ADDENDUM NO. 1

November 4, 2025

Schoellkopf Memorial Hall Men's Locker Room Renovation

**SCHOELLKOPF
MEMORIAL HALL
MEN'S FOOTBAL
LOCKER ROOM
RENOVATION**

A-601R
17245792

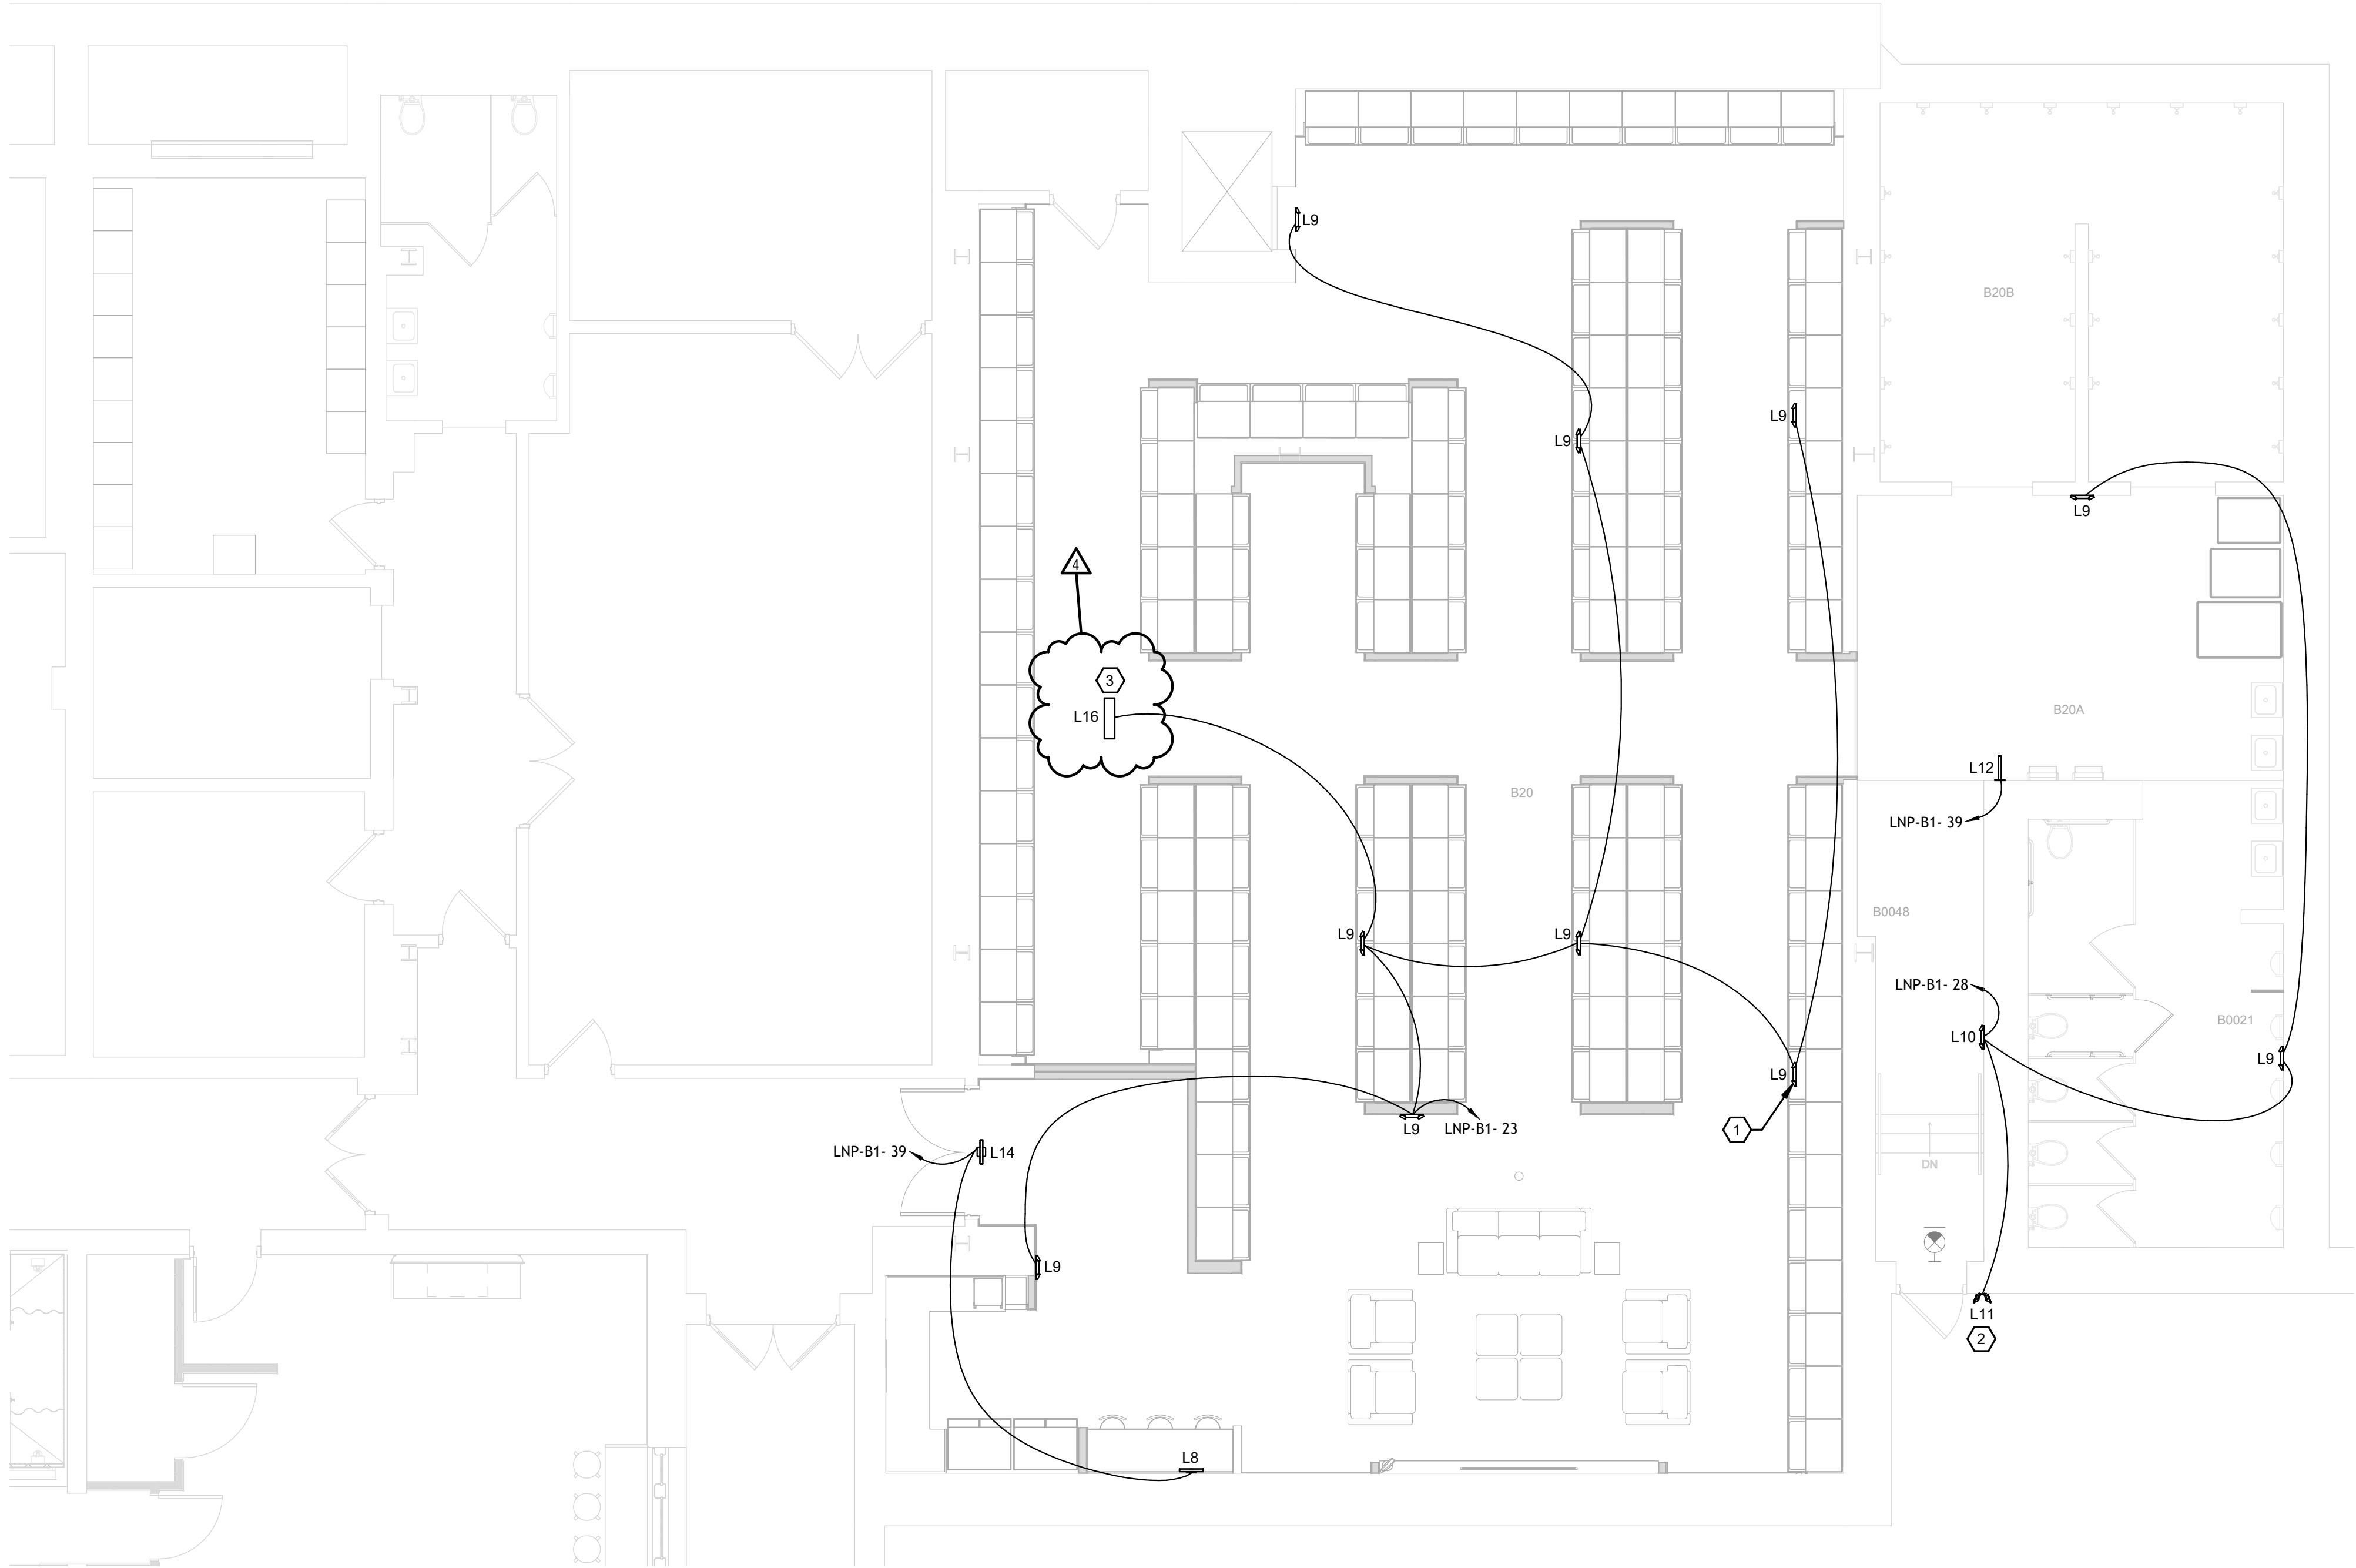
ADD Keyed Note #2.

2 REFER TO DRAWING A-601R FOR ADDITIONAL A/V SCOPING NOTES.
